UNITED STATES PATENT AND TRADEMARK OFFICE

APPLICATION NO.	FILING DATE	FIRST NAMED INVENTOR	ATTORNEY DOCKET NO.	CONFIRMATION NO.
09/846,317	05/02/2001	Takehiro Shiimoto	925-193	4714

Office Action Summary

DETAILED ACTION

FIG. 5

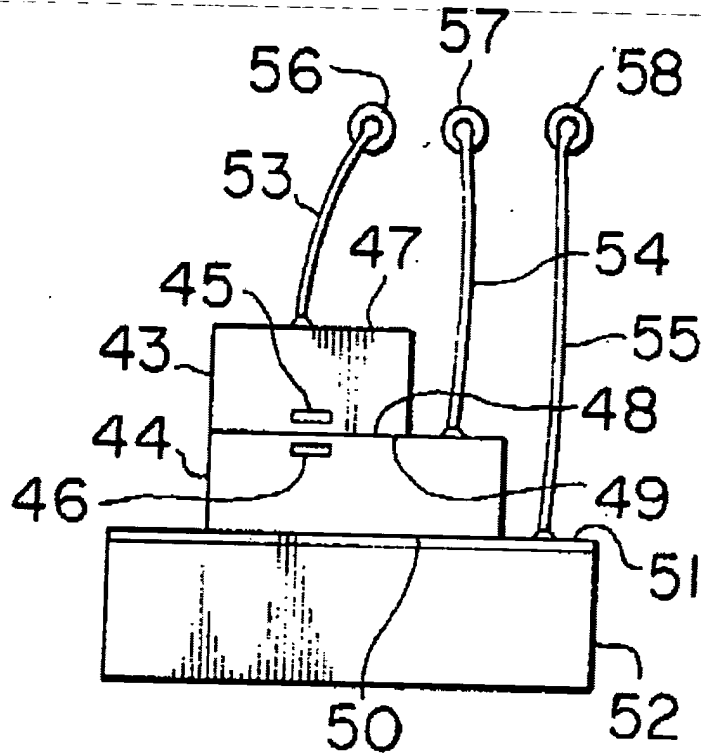
With respect to claims 1 and 7, Kato discloses semiconductor laser device comprising a stem having mounting surfaces (48, 49), the first semiconductor laser element (44) having a first emission wavelength 780 nanometers, the second semiconductor laser element (43) having a second emission wavelength 830 nanometers. It is inherent that each of the first and second semiconductor laser elements (44 and 43) has a first and second “temperature dependence” respectively and further that the second temperature dependence is lower than the first temperature dependence as claimed because Kato meets all the claimed structure limitations as discussed above, note cols. 13 line 64 to col. 15 line 64, see fig 5 below.

With respect to claim 3, Kato discloses the second semiconductor laser element (43) provided on top of the first semiconductor laser element (44) is smaller in size than the first semiconductor laser element, see fig 5 above.

FIG. 2

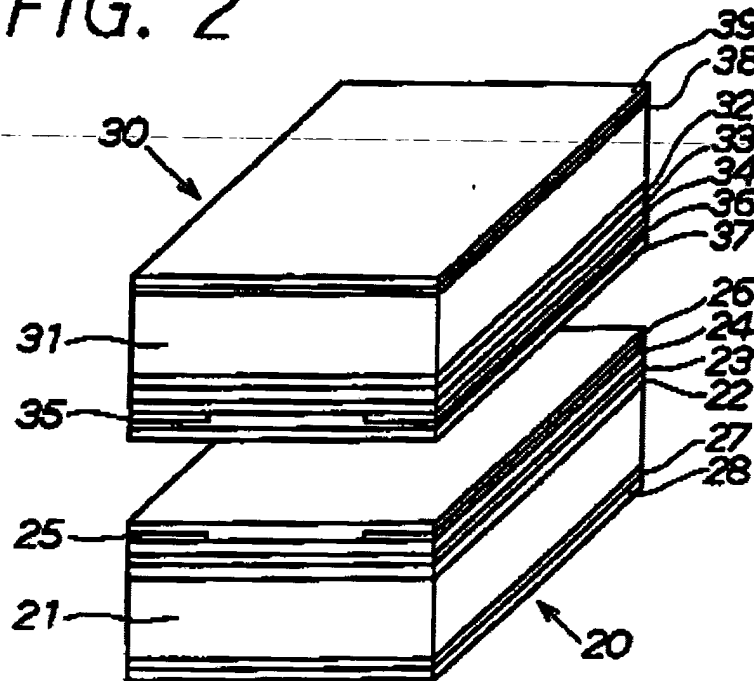
With respect to claim 4, Kato et al discloses all above except for the first and second semiconductor laser elements has an N-layer and a P-layer, and either the N-layers or the P-layers of the first and second semiconductor laser elements are adjacent to each other. Whereas Otsuka et al discloses the first and second semiconductor laser elements (20, 30) has an N-layer and a P-layer, and either the N-layers or the P-layers of the first and second semiconductor laser elements are adjacent to each other, note cols 3-6, see fig 2 below. For the benefit of the stack type semiconductor laser device, it would have been obvious to one having ordinary skill in the art at the time the invention was made to provide Kato with the stack type semiconductor laser device as taught or suggested by Otsuka.
